Overview

August 15, 2018 | 5:00 p.m. to 7:00 p.m. | CitySpace

The Open House was held on August 15, 2018 to allow the public and stakeholders to view the streetscape concept that was developed based on previous engagement events, including the Streetscape Summit, MetroQuest Survey, and Steering Committee meetings. The event was designed as an informal meeting with large plots of the concept, illustrative cross sections, traffic exhibits, and a summary of engagement results. In addition to collecting general comments, the Open House collected specific feedback on priority considerations (as identified in earlier engagement efforts) and access control at two locations along the corridor. Attendees received a worksheet to make it easier for them to weigh in on these elements.

Sketches

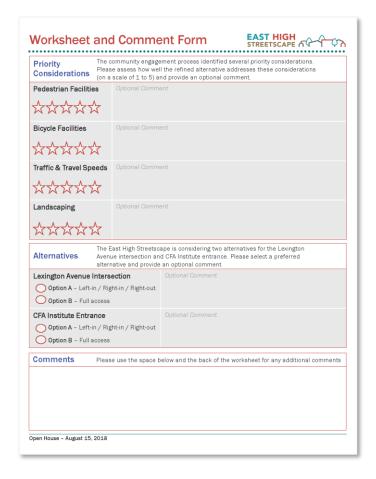
I thinh his is soler:

OPTION = ORASS

CAR
